ELECTRIC INSTALLATION

4681 W. 46TH AVE., DENVER, CO.

2025-UTIL-0000276

ELECTRIC INSTALLATION
4681 W. 46TH AVE.
DENVER, CO.
CCD COMMENT REPORT

UTILITY PLAN

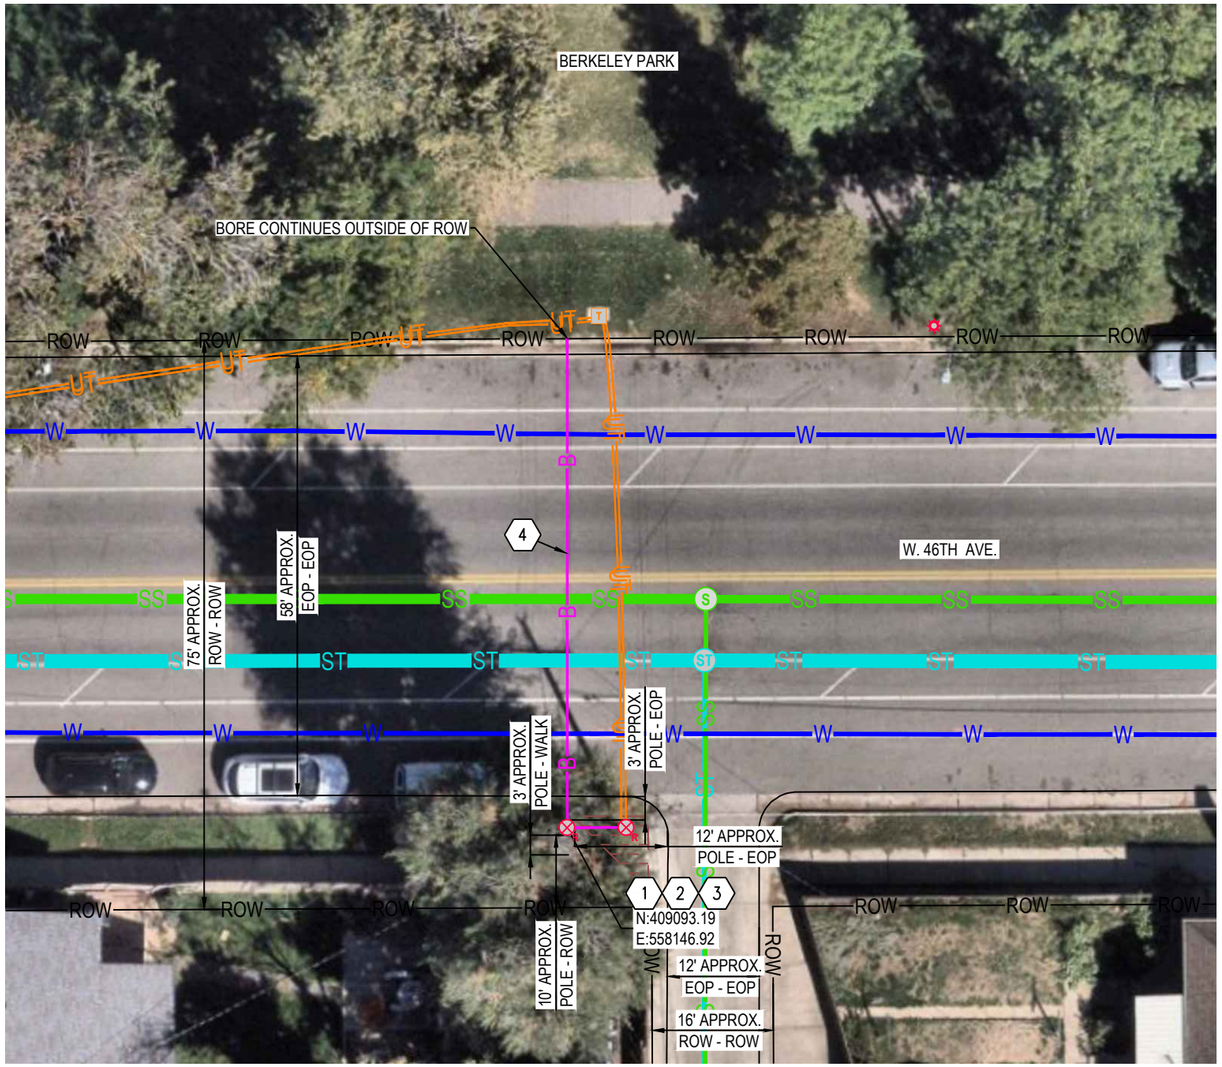
Status Date: 12/30/2025
Status: Denied POLE HAS BEEN RELOCATED OUT OF THE SIGHT TRIANGLE.
Comments: 1. Pole is located within the pedestrian sight triangle. Please remove or relocate proposed pole.
